INSTRUCTION TO SERVICE

ITS: 6254

SECTION:	260 Battery Compartment
WRITTEN BY:	Alan Mark
SUBJECT:	Reconfigure Voltage Sense Connection

Figure 2: Fuse box left side interior diagram

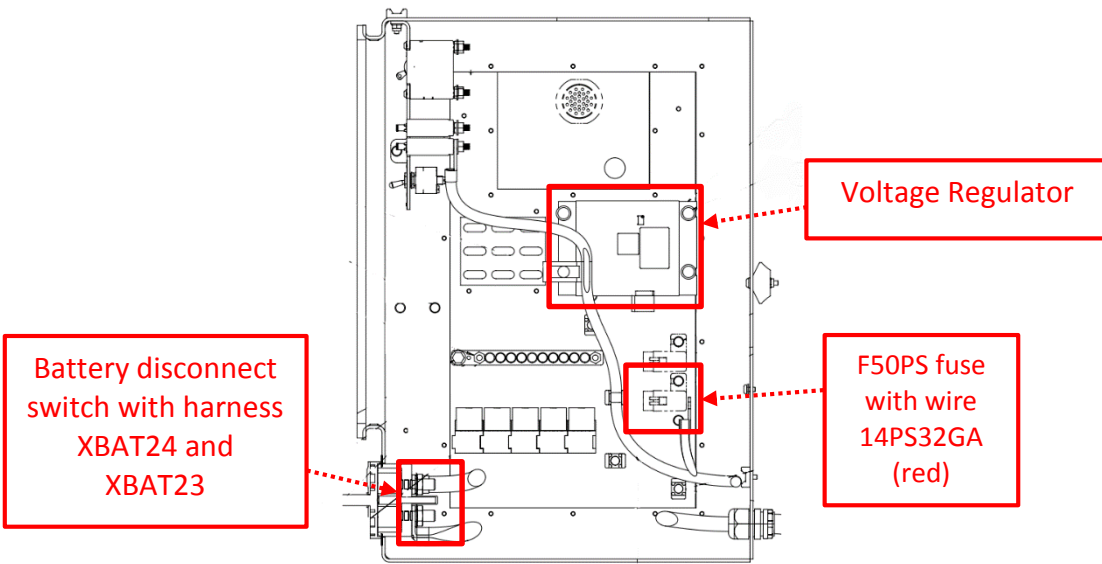
3. Locate the fuse box by gaining access through the rear panel access door on the curbside of the bus as seen in Figure 1 above.
4. Seen in Figure 2 below is the left side interior view of the fuse box. Locate the harness “XBAT24A” and the wire labelled “14PS32GA” which connects from the fuse “F50PS”.
5. Disconnect the wire from cavity “A” on the harness “XBAT24A” tower. Figure 3 and Figure 4 below displays the wiring diagram.
6. Remove the male terminal and strip the wire to allow the wire to be terminated with a socket (P/N: 102879).
7. Connect the wire “14PS32GA” to the new socket location in cavity “B” of the shroud for harness “XBAT23” as shown in Figure 3 and Figure 4 below.
8. Remove all tools and debris and return the bus to service condition.
9. Turn the main battery disconnect switch to the “ON” position.
